Town of Brookfield
645 N. Janacek Road
Brookfield, WI 53045
(P) 262-796-3788
(F) 262-796-0339

MEETING NOTICE

Tuesday, August 26, 2025

AGENDA

Located at 20815 Brook Park Court

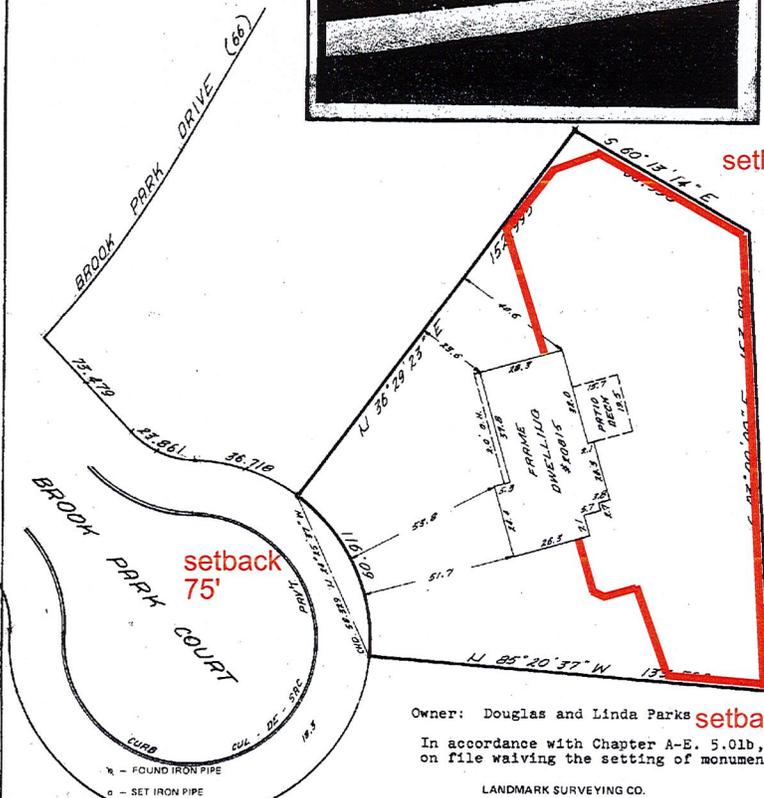
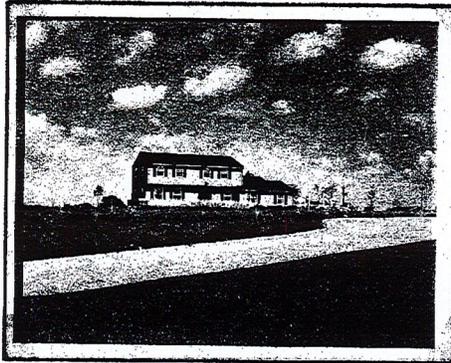
The Town adopted a revised fence Ordinance in 2023 that states any solid fence located within three (3) feet of the property line requires a Conditional Use Permit. The Ordinance requires that a Plat of Survey be submitted depicting the location of the proposed fence. The owner has submitted a Plat of Survey with the proposed fence location drawn on the survey (enclosed), but the location of the fence was not staked by a surveyor. The Plan Commission should determine if an updated Plat of Survey is required with the proposed fence location staked on the survey. A rendering of the fence is enclosed.

1. A revised Plat of Survey shall be furnished with the proposed fence location staked on the survey to ensure it will not encroach on the neighboring properties, prior to the issuance of a fence permit by the Building Inspector.
2. The finished side of the fence shall face the neighboring property owner and the fence post face the subject property.
3. The fence shall not exceed 6 ft. tall, as proposed.

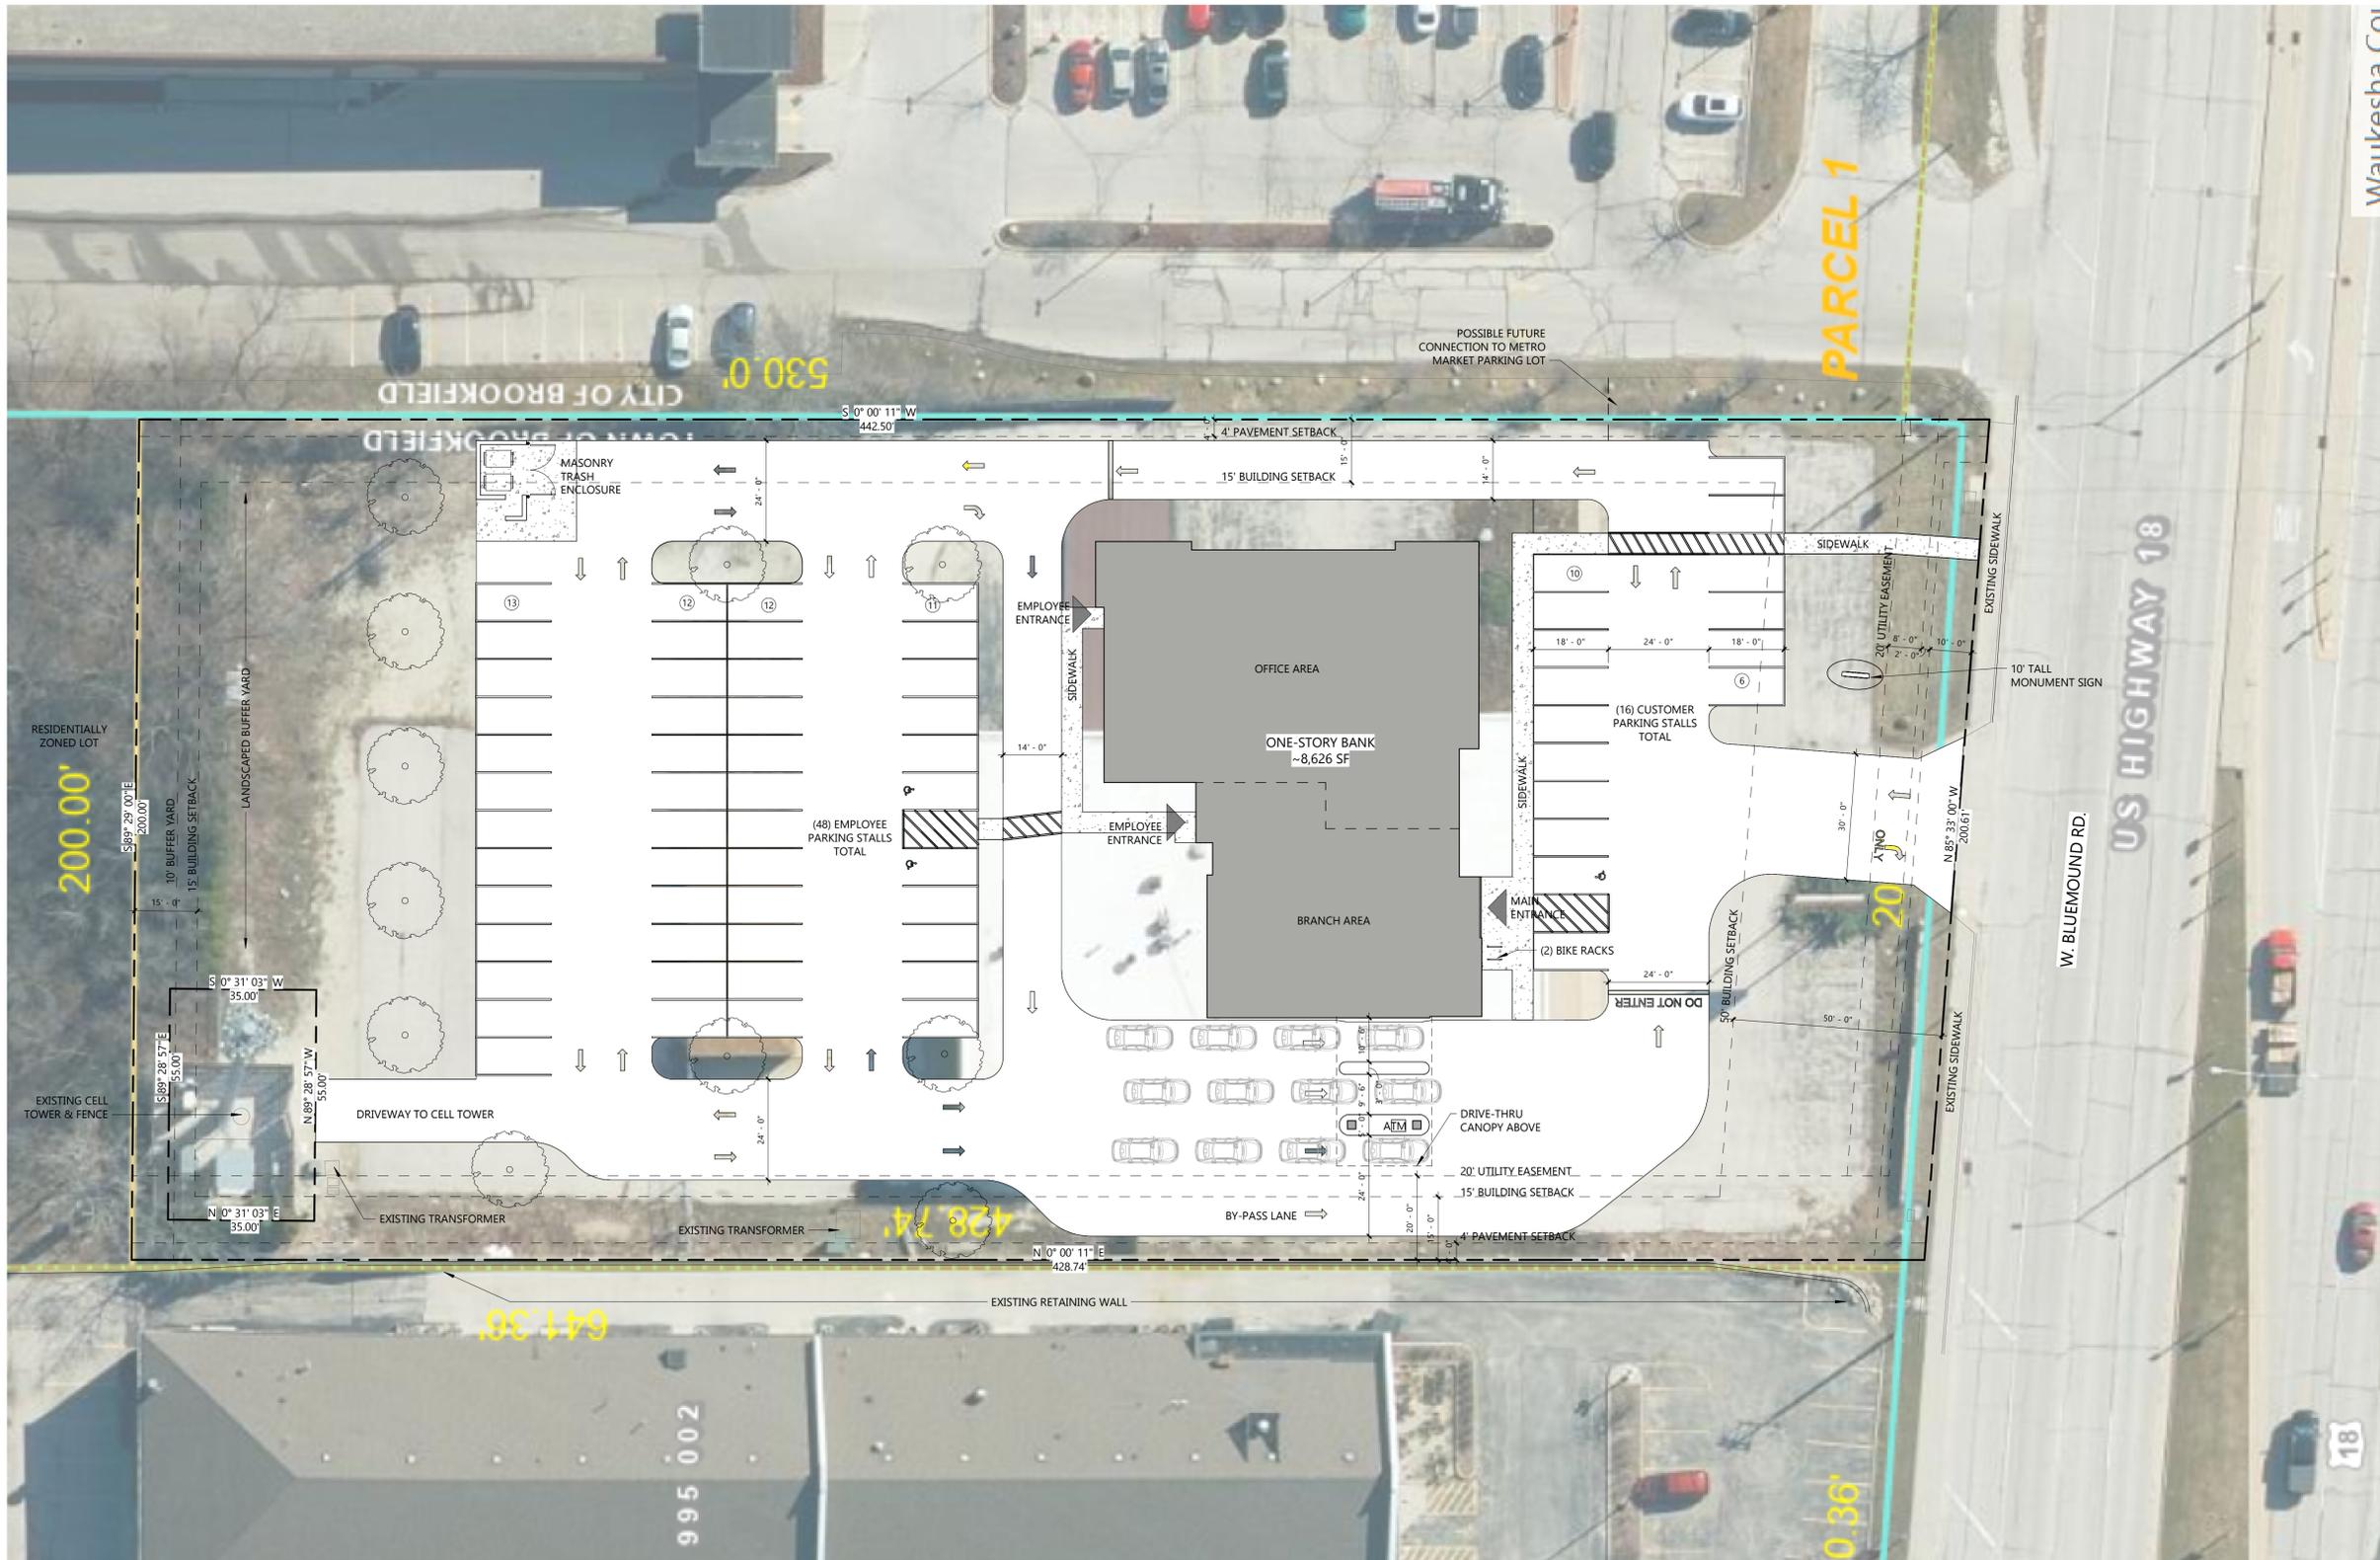
Off-street parking: The area for customer service is approximately 2,300 sq. ft., which would result in 16 required customer parking spaces (1 space/150 sq. ft. of space reserved for customer service). There are 48 employee parking spaces proposed. However, a maximum of 28 employees are anticipated per shift (1/employee required). Some of the additional stalls may be utilized for stockpiling snow in the winter. The site plan identifies that the drive-in service lane can accommodate four waiting vehicles and a by-pass lane. The proposal meets the requirement.

- Spaces are 9’ x 18’ with a 24’ drive aisle. One aisle handicap stall is proposed in the customer parking area and two aisle handicap stalls are proposed in the employee parking area.
- A 10 ft. pavement setback is not being met to the east and west. The site plans note a 4 ft. requirement, which is the curb setback for parking.
- Parking is more than 25 ft. from the adjacent residential properties to the north.
- Parking lot islands and peninsulas are proposed at the end of aisles. Landscaping will be addressed in the future.
- A minimum 10 ft. landscape buffer yard is proposed along the north property line between the parking and the adjacent residential district.

Staff recommends that the Plan Commission make a recommendation to the Town Board to grant Conceptual Approval to allow a financial institution on the property located at 17740 W. Bluemound Road, subject to the following condition:

1 ARCHITECTURAL SITE PLAN

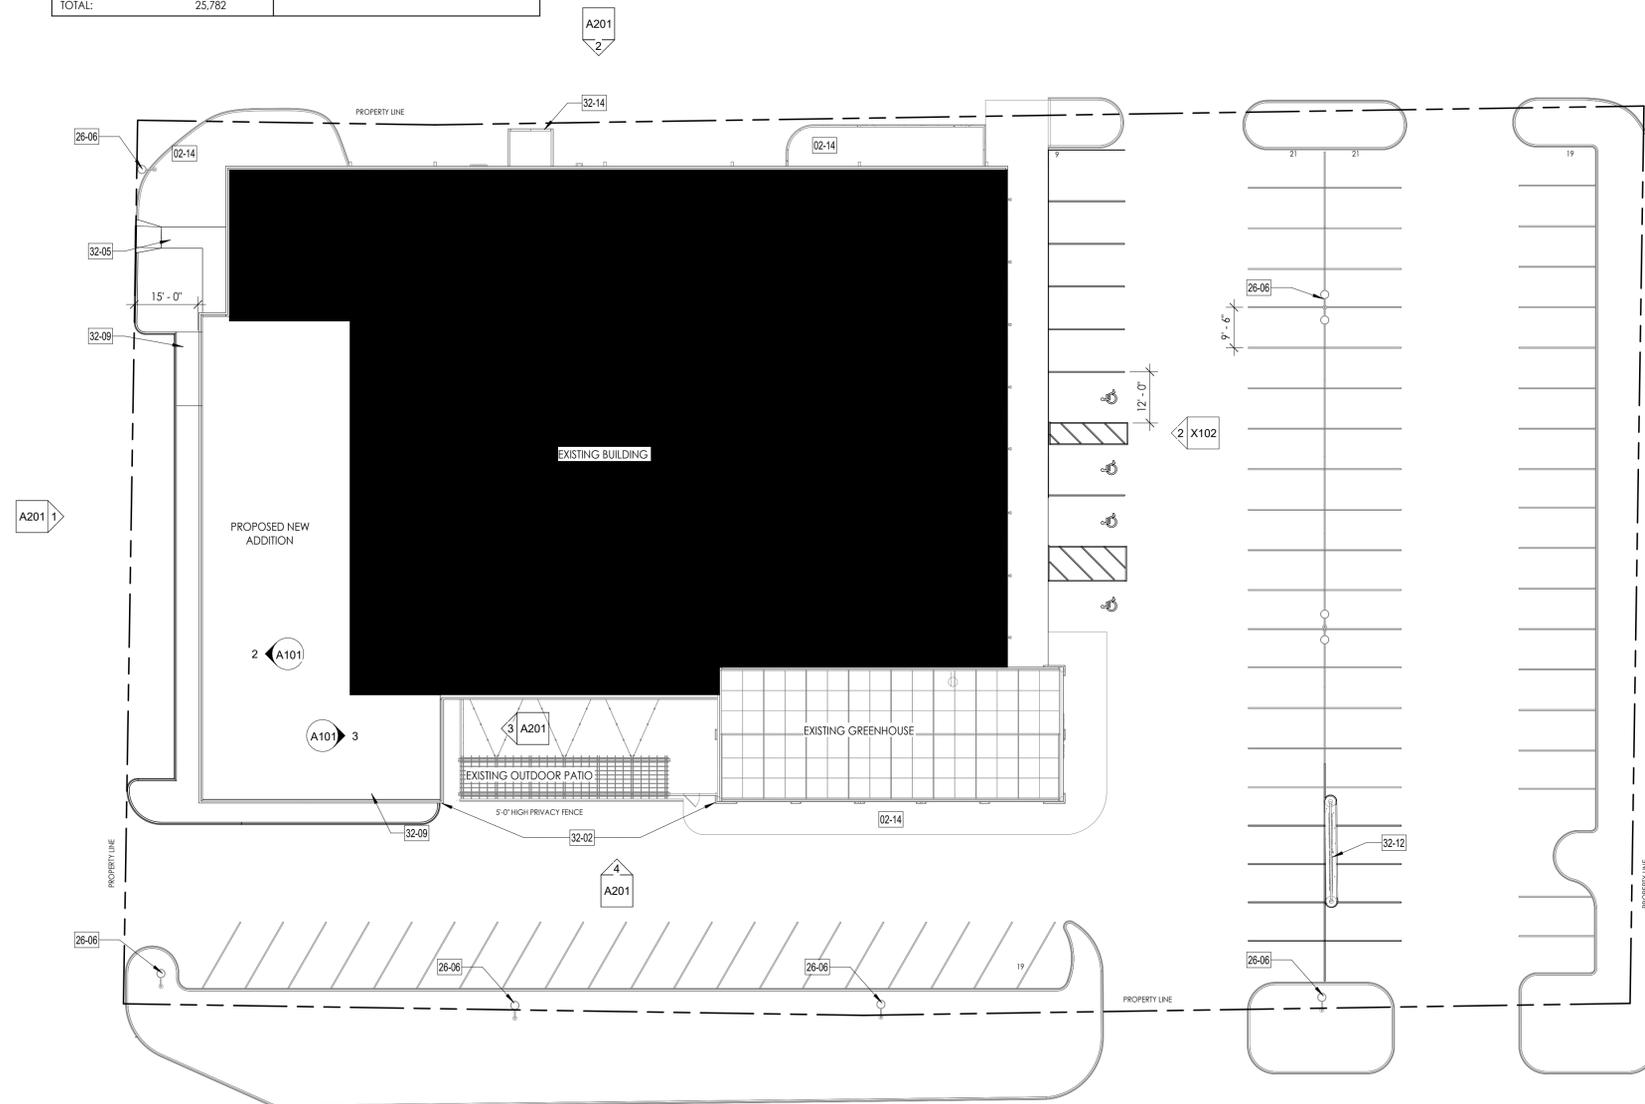
Parking: Eight parking spaces underneath the carport will be eliminated. Six compact parking spaces will be added to the main parking area around the existing sign. The petitioner does not anticipate needing to make changes to the sign to accommodate this. All spaces will be pavement parked for compact cars. Two additional ADA spaces will be added near the entrance and four parallel stalls will be added on the west side of the building addition (not currently shown on site plan). This results in four additional parking spaces on site. While the existing site does not have enough parking to satisfy the code requirements, there is a parking easement recorded in the Register of Deeds (Document No. 1451917) that states parking for the subject parcel may have the benefit of utilizing the parking areas of Parcel 1, in common with Galleria and all tenants. The owner has shared that given the nature of their business and employees coming and going, additional parking is not needed. With the shared parking easement, consideration should be given if the parking requirement is satisfied.

Ingress/Egress: The northwest entrance to the site will be removed. A fire truck access plan is included in the civil packet (C201).

Staff recommends that the Plan Commission make a recommendation to the Town Board to grant Preliminary and Final Approval to the Town Board to allow the petitioner to construct an addition onto the existing building located at 19000 W. Bluemound Road, subject to the following condition:

① SITE PLAN
1" = 40'-0"

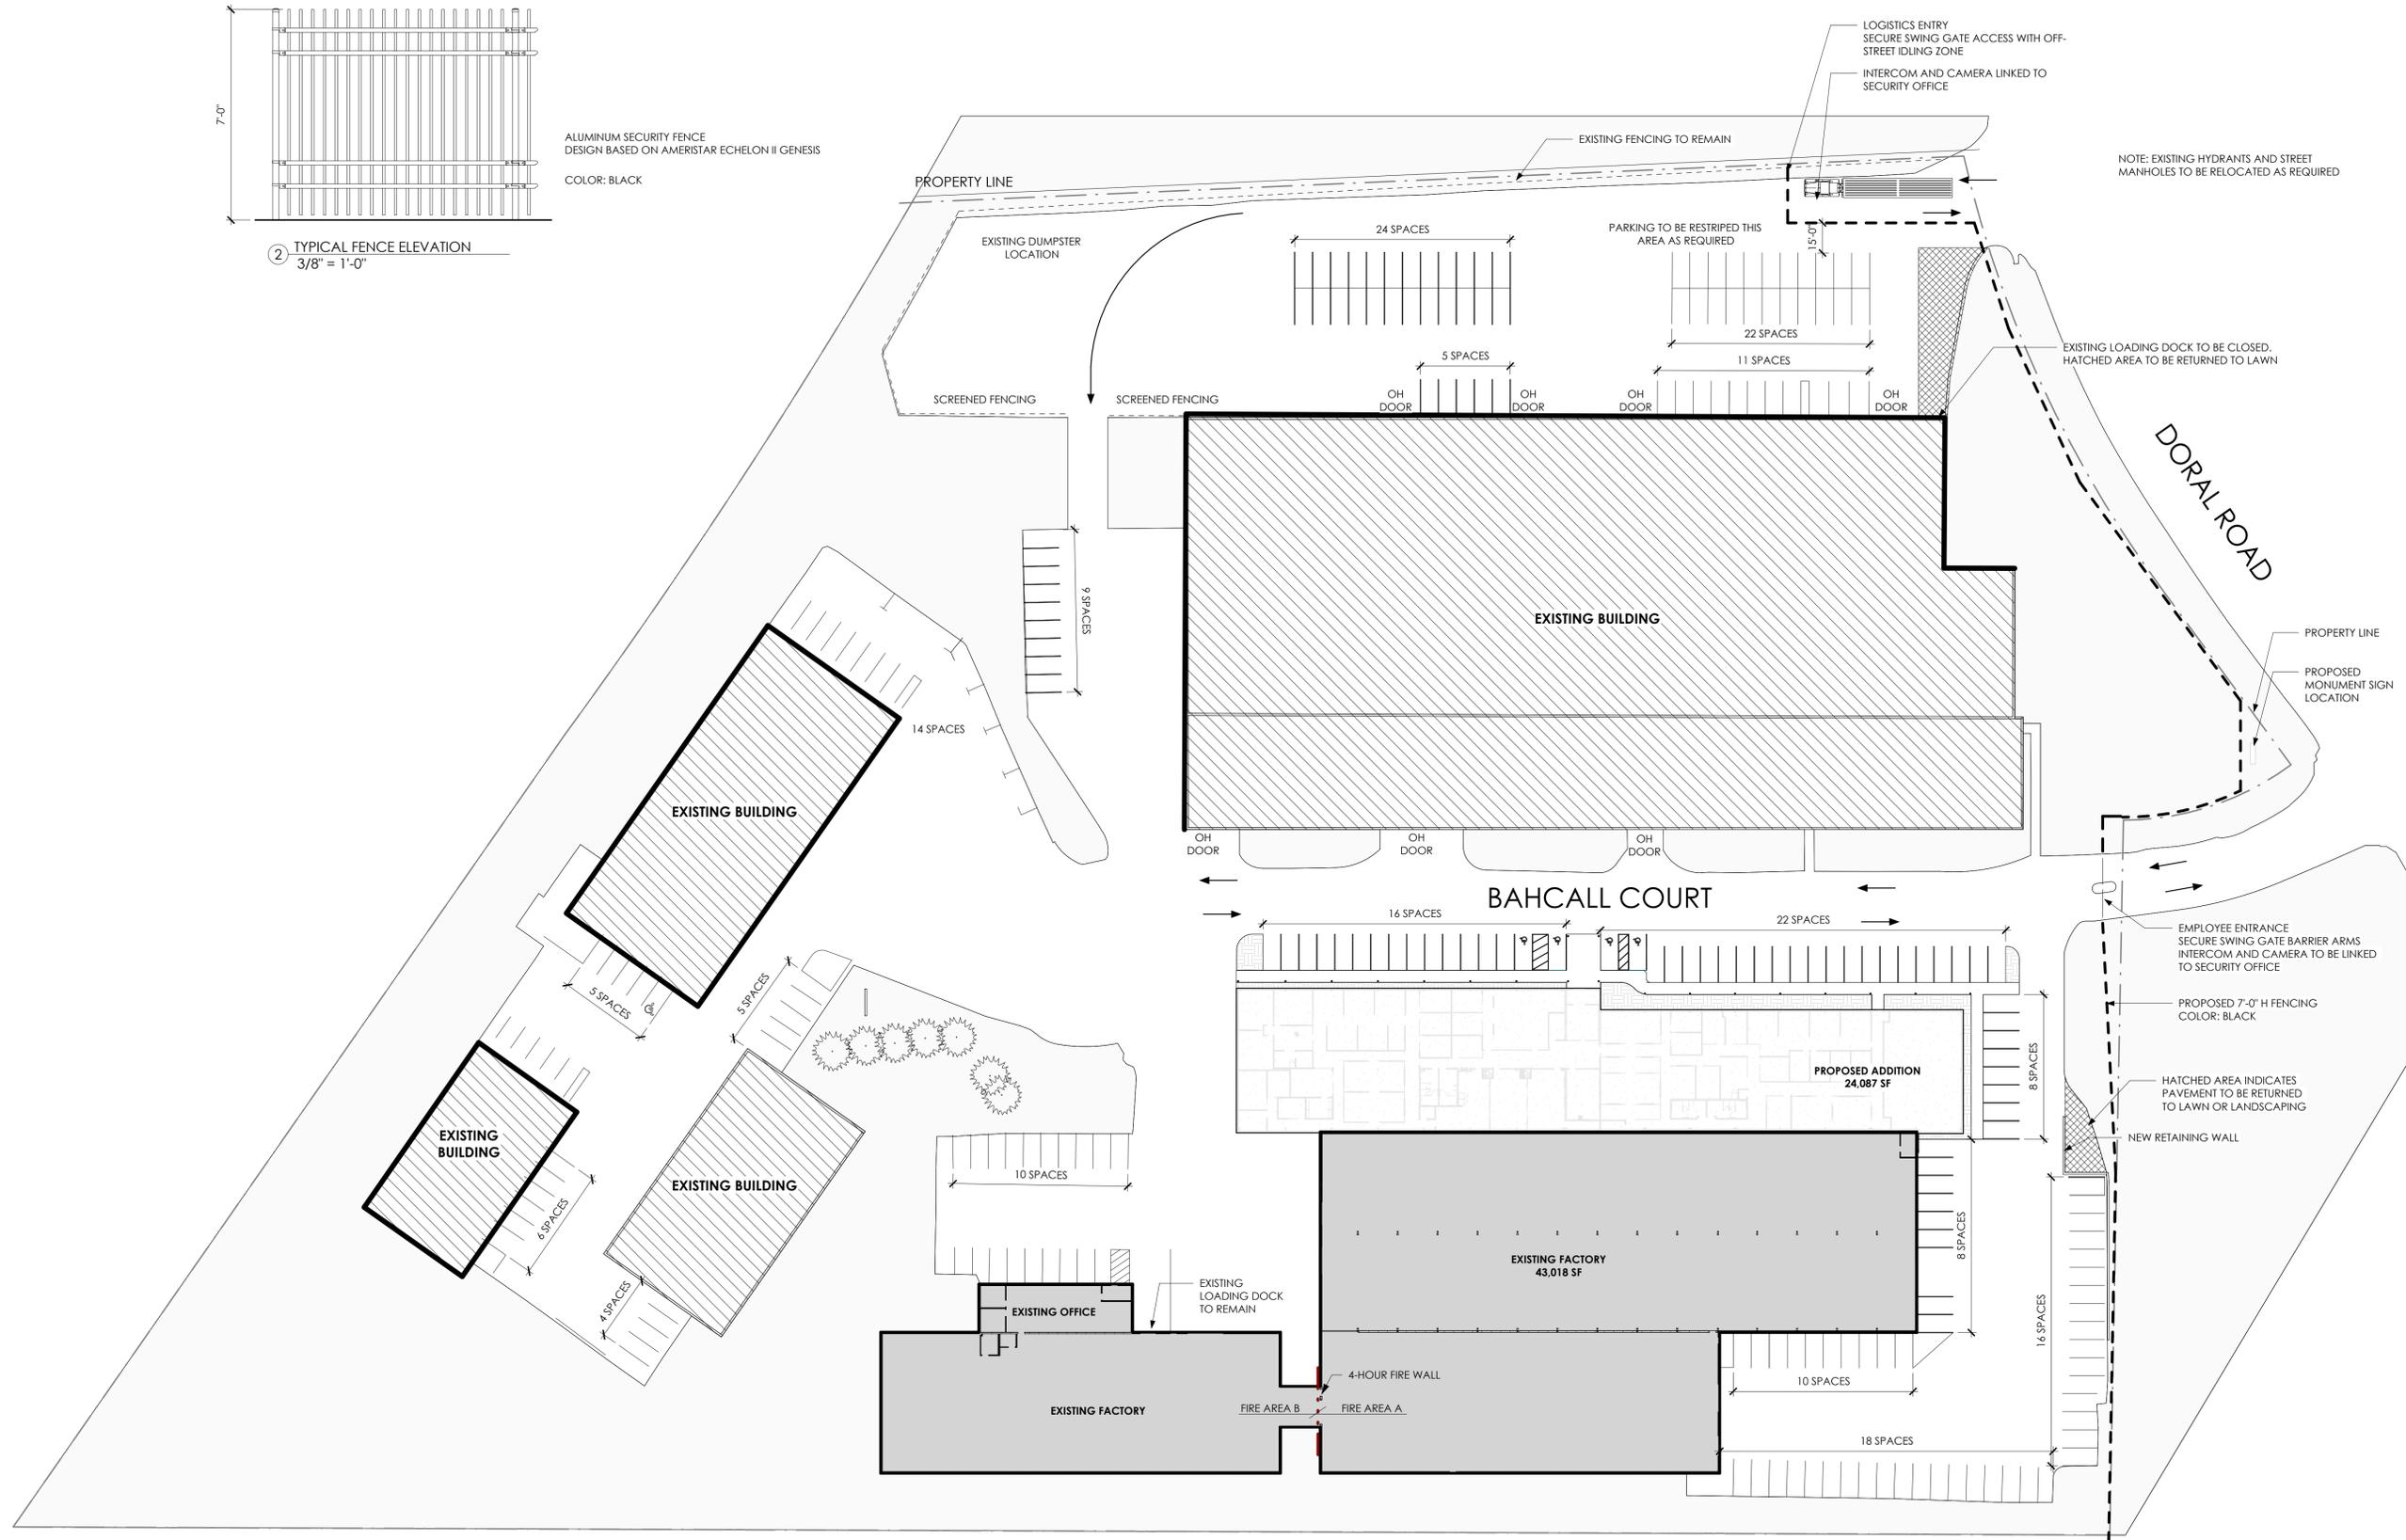
Engineering: Minor comments/clarification need to be addressed, including an erosion control plan and a utility plan. The main comment is regarding the existing fire hydrant located in the proposed parking stalls north of the addition. Grading for Phase I is not being proposed. Stormwater management will be addressed during Phase II.

- A 7'-0" high decorative security fence will be constructed along the north property line. An elevation of the fence is shown on sheet A0.41. The fence will be black.
- Currently, the south, and west, property lines are secured with a 6'-0" high chain link fence.
- Visitors will check in at a camera/intercom installation at the visitor gate on Bahcall Ct. and trucks will check in at a camera/intercom installation at the west gate along the west property line.
- All requests for site entry will be routed to the security office located next to the office entry vestibule.

1. All comments of the Town Engineer be addressed, prior to Town Board approval.
2. The applicant prepare an emergency access plan for the swing up gates that is submitted and approved by the Fire Department.
